Prelim Adq Lockhart Pit

**Re: Lockhart Pit; Permit M2024017
DRMS Preliminary Adequacy**

Please find the Divisions preliminary adequacy questions regarding the Lockhart Pit for your resolution. DRMS found the proposed application incomplete on 6 May 2024. The Division found the Kremmling All Seasons's Rental LLC, Lockhart Pit 112c application complete on 23 May 2025 having received the application on 25 April 2024.

Rule 6.4.1 Exhibit A

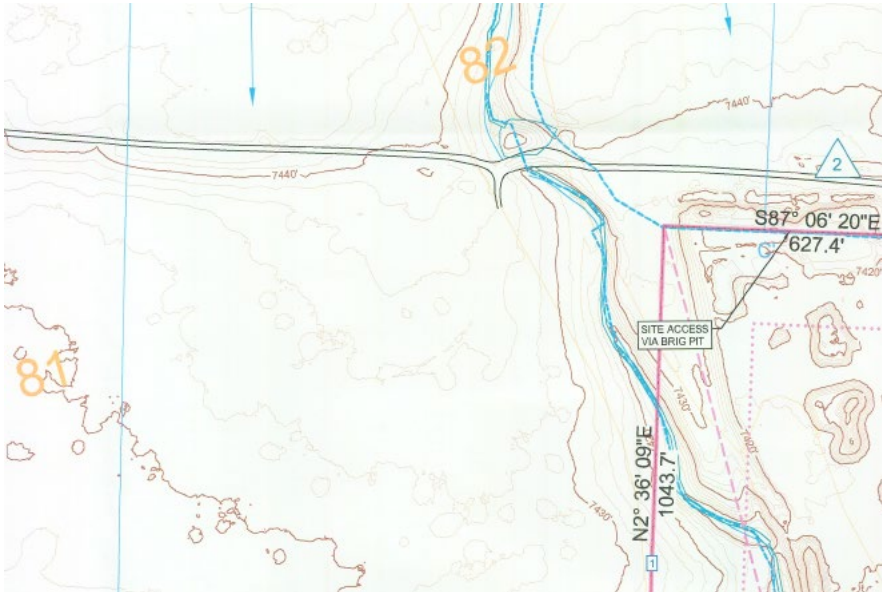
5. The C-1 Baseline Map indicates site access through the Brigg Pit/Bumgarner Pit. This appears to be a private road to the Brigg Pit. If the operation utilizes the private road for access to the Lockhart Pit, please demonstrate to DRMS that you have right of entry through the Brig Pit /Bumgarner Pit for stated mining operations.
6. Legal description places the site in Range 80 West, however Map C-1 exhibits labels for Ranges 81 and 82. Please clarify and change the map accordingly and resubmit the corrected map.

7. Surface owners of record are not labeled on Map C-1. Please label any and all surface owners of record and resubmit the map.

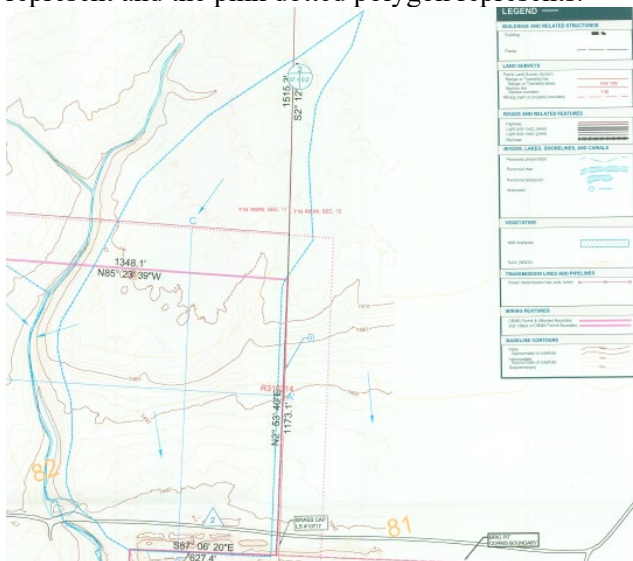
The legend is ambiguous in the hydrology section as it relates to the map (Maps C-1 and C-2) as it proposes legend items that are not employed on the map. Please use a bespoke legend pertinent to the mapped items.

8. Please, in the legend indicate what the blue dashed polygons (appear to be hydrologic basins) represent and the pink dotted polygon represents.

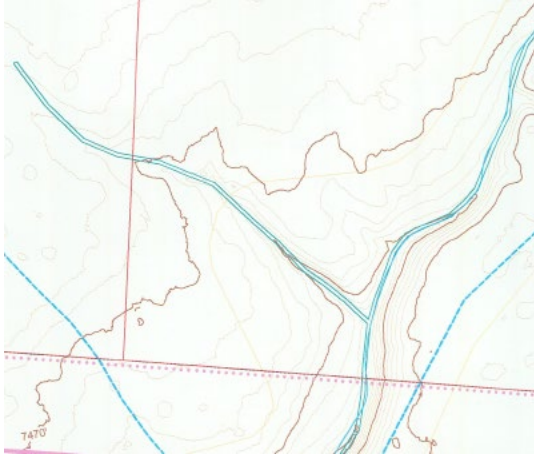
9. It appears that unnamed ephemeral waterways are depicted. It is unclear between the legend and the map depiction whether the below illustration depicts perennial or ephemeral streams, please clarify and call out ephemeral drainages in the legend to correspond with the map depiction
